Ecological Review and Request for Further Information for a Proposed Residential Subdivision at Mt Welcome Station, Pukerua Bay

Prepared for:	Porirua City Council	Reviewed and approved for release by:  Nick Goldwater Senior Principal Ecologist
Author:	Nyree Fea	
Report No:	7831b	
Date:	May 2026

Mt Welcome PCC terrestrial ecology review response

Wildlands Response to Applicant's Response to Minute 3 of the Panel Convener

Figure 1: Aerial photo of main farm track with indigenous planted vegetation above the road in lighter green

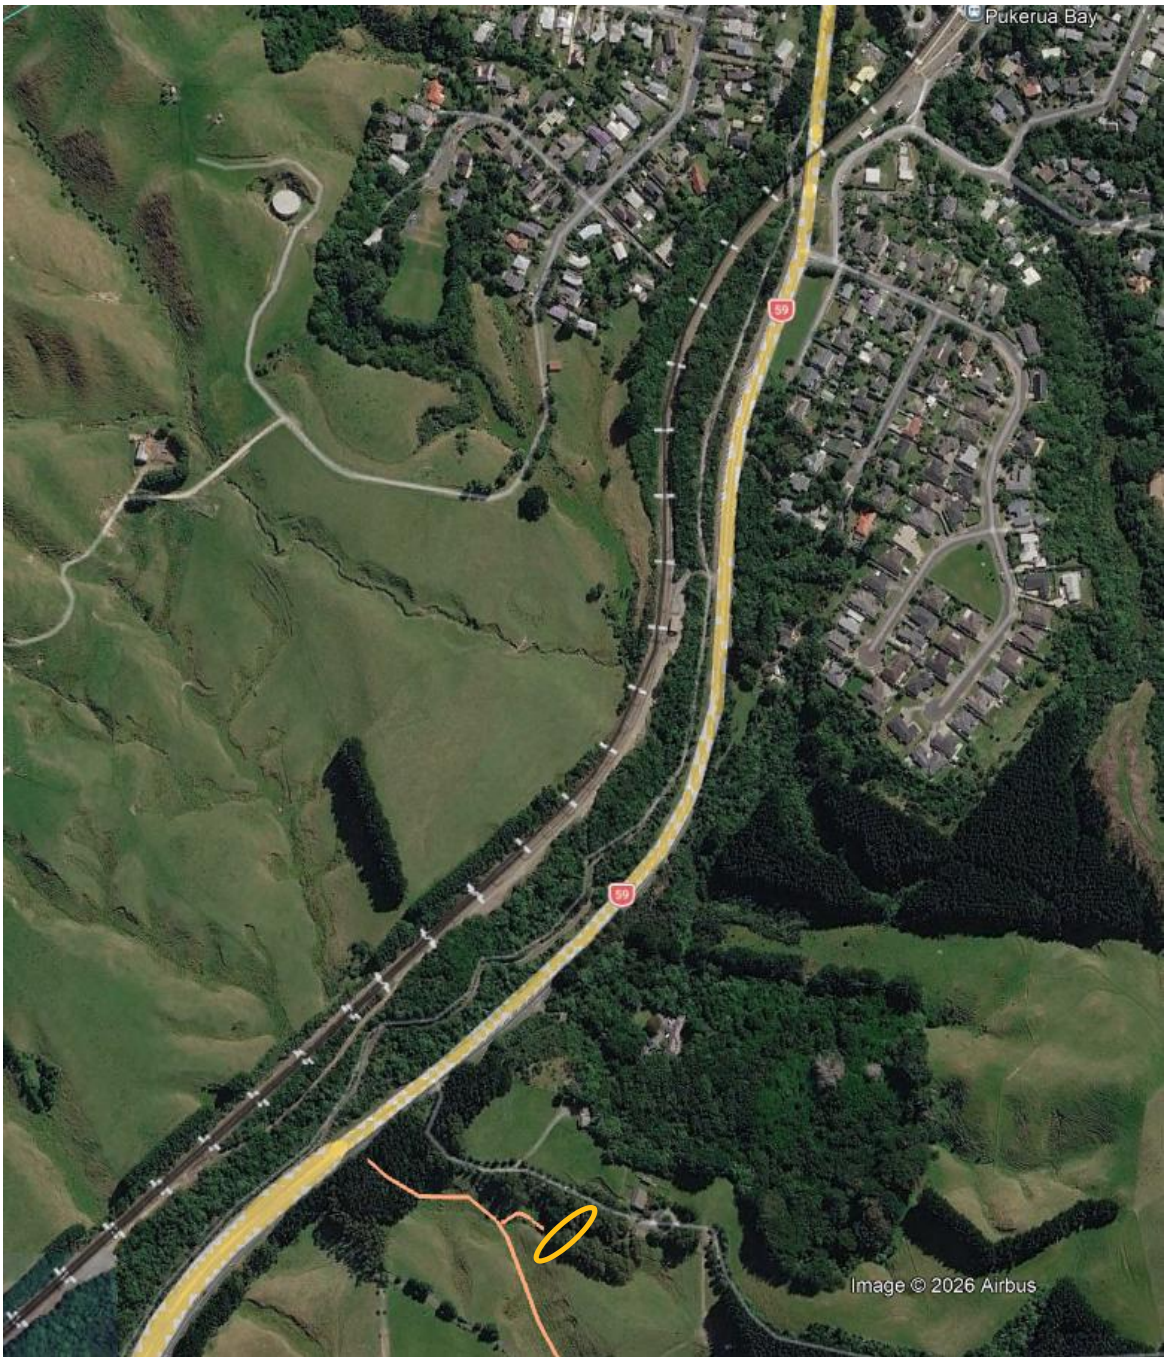
I note that the reviewers also seek to add 2,380m² of "similar aged" indigenous dominant scrub for the subdivision will need to be cleared (section 4.1.3). They do not identify where this is, but I assume that this is the planted native piece above the main farm road and set back from the pine edge as shown in Figure 1 below.

While the reviewers agree that this area is not significant in terms of the RPS criteria or the NPS IB, they consider the loss of the plantation is not negligible because of the land environment class in which it sits. It arguably sits on the boundary of the < 10% land form with cover of indigenous vegetation and the 20-30% remaining and arguably in this latter class.
